REVISED RESPONSE TO REQUEST FOR ADDITIONAL INFORMATION

APR1400 Design Certification

Docket No. 52-046

RAI No.: 437-8540
SRP Section: 08.01 – Electric Power – Introduction
Application Section: 8.1
Date of RAI Issue: 03/08/2016

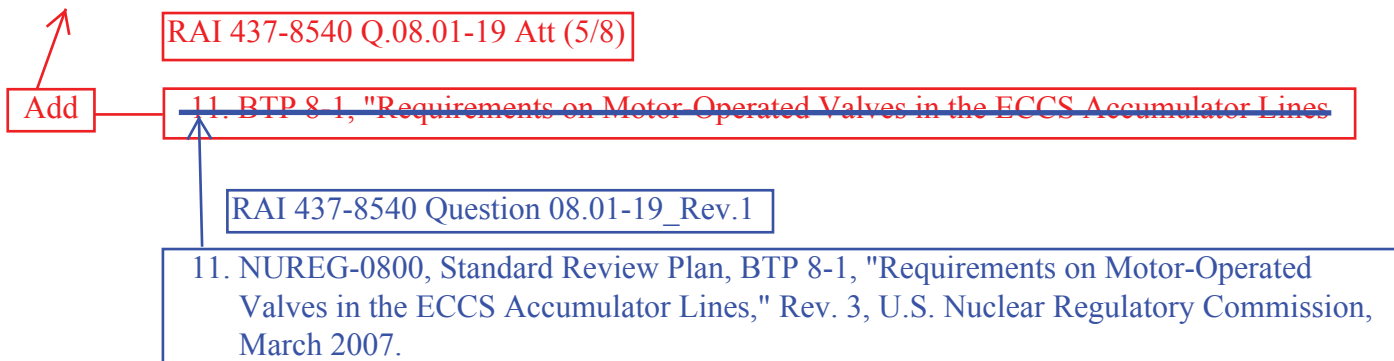
in accordance with BTP 8-1 (Reference 11)

Add

7.6.1.4 Component Cooling Water Supply and Return Header Tie Line Isolation Interlocks

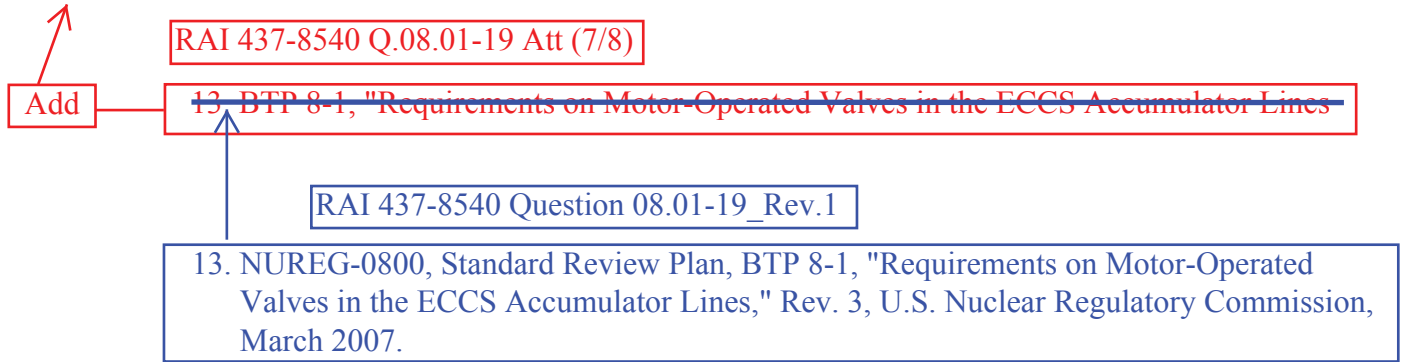
Add

in accordance with BTP 8-1 (Reference 13)
